NOTICE OF PROPOSED CHANGE IN PROPERTY

Petition: x1823

B						CONVERSION TO EASEMENT THE EAST/WEST PUBLIC ALLEY, 16 FT. WD. IN THE BLOCK BOUND BY LONGFELLOW, McQUADE, W. CHICAGO AND DEXTER AVE.	CITY OF DETROIT CITY ENGINEERING DEPARTMENT SURVEY BUREAU	
A							JOB NO. 01-01	
DESCRIPTION		DRWN	CHKD	APPD	DATE		DRWG. NO. X 1823	
REVISIONS								
DRAWN BY WLW		CHECKED KSM						
DATE 03-02-18		APPROVED

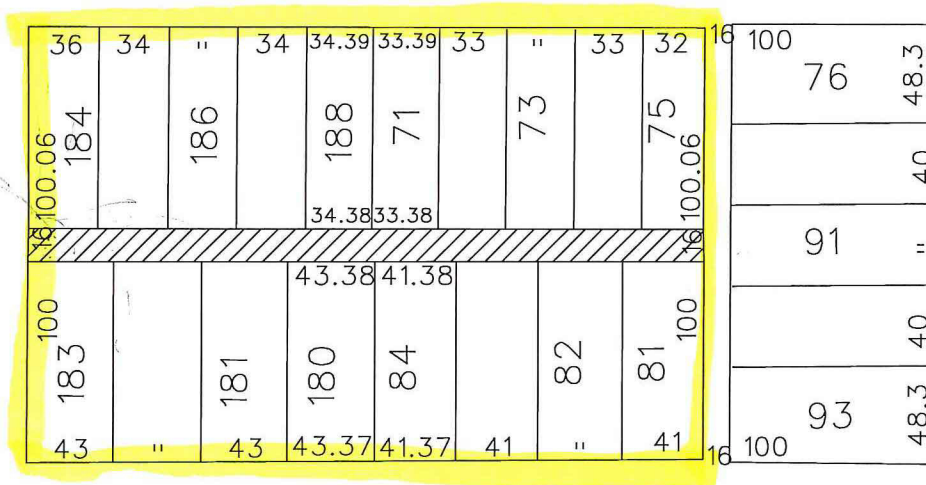
- Involved; the nature of our services and the estimated costs of removing and/or rerouting such services are:
① \$1,577.93 - TO REMOVE SECONDARY CONDUCTORS (2 SPANS),
TOP CUT 2 POLES, & TRANSFER OWNERSHIP OF OPL.
OR ② \$2,363.87 - TO REMOVE SECONDARY CONDUCTORS (2 SPANS),
TOP CUT 2 POLES, REMOVE OPL & OPL FEED.

PLEASE CHOOSE ONE OPTION.
